Application for Works Approval

Works Approval Number	W6205/2018/1
Applicant	Abra Mining Pty Ltd
ACN	110 233 577
File Number	DER2018/001572
Premises	Abra Base Metals Project General Purpose Lease G52/292 MEEKATHARRA WA 6642
Date of Report	28 June 2019
Status of Report	Draft for Internal Review

Figure 2: Plant Layout

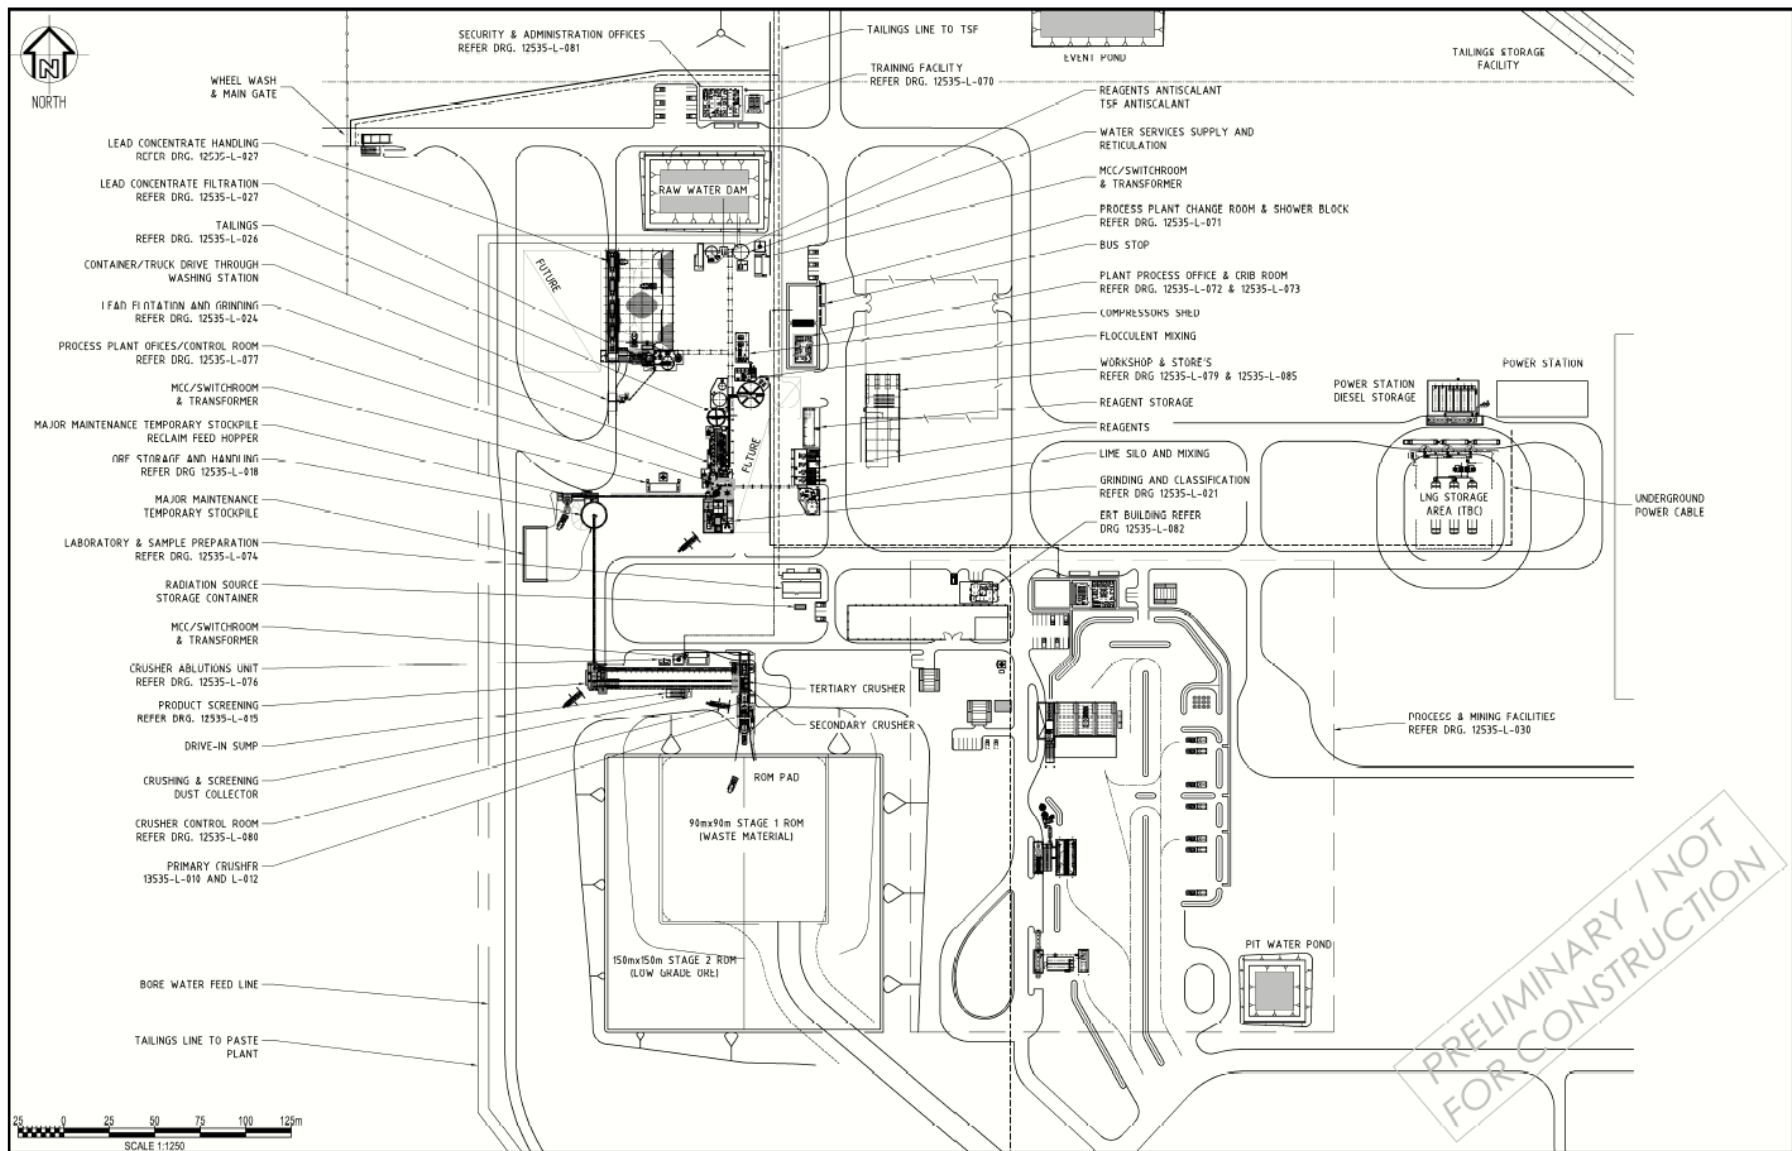
Condition	Summary of Applicant’s comments	DWER response
Works Approval		
Condition 4 – Table 2	Table 2 specifies the single crusher and SAG mill but Site Plan 1 clearly shows the three crushers	Table amended

Figure 6: Minor catchments (C, D and E) around plant area (Rockwater, 2018). Final infrastructure layout has been realigned to avoid drainage line.

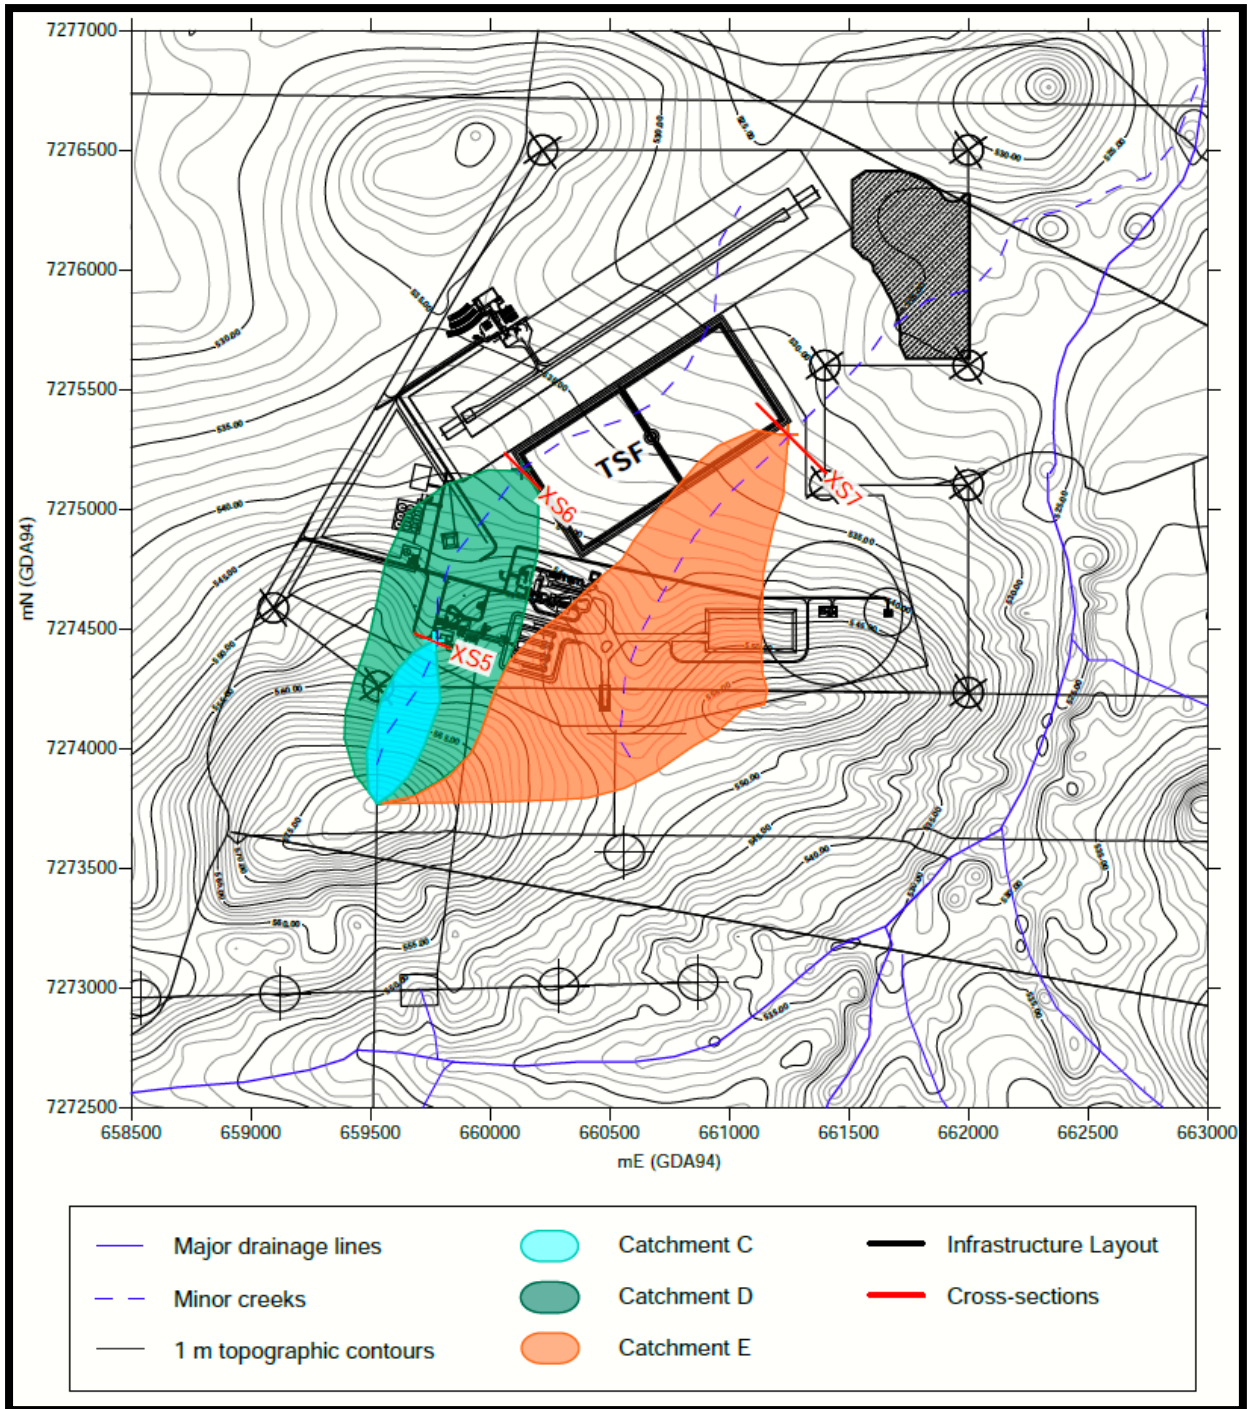
The Abra lead-silver deposit is located near major drainage lines, in an area subject to high flood flows. The project is elevated well above the surrounding major drainage lines. However, the project's planned infrastructure intersects or lies close to two minor creeks. There are two major catchments (A and B – Figure 5) with the potential for peak flows to impact the project area and underground mine, and three smaller catchments (C, D and E – Figure 6) that could impact the project's surface infrastructure.

The hydraulic analyses presented in the Rockwater Surface Water report (September 2018) indicated that the peak flows resulting from these catchments would not impact on the project area and underground mine. However, the planned infrastructure, in particular the TSF, intersects or is close to two minor drainage lines which flow northwards. High rainfall events could result in flooding and potential damage to the TSF walls.
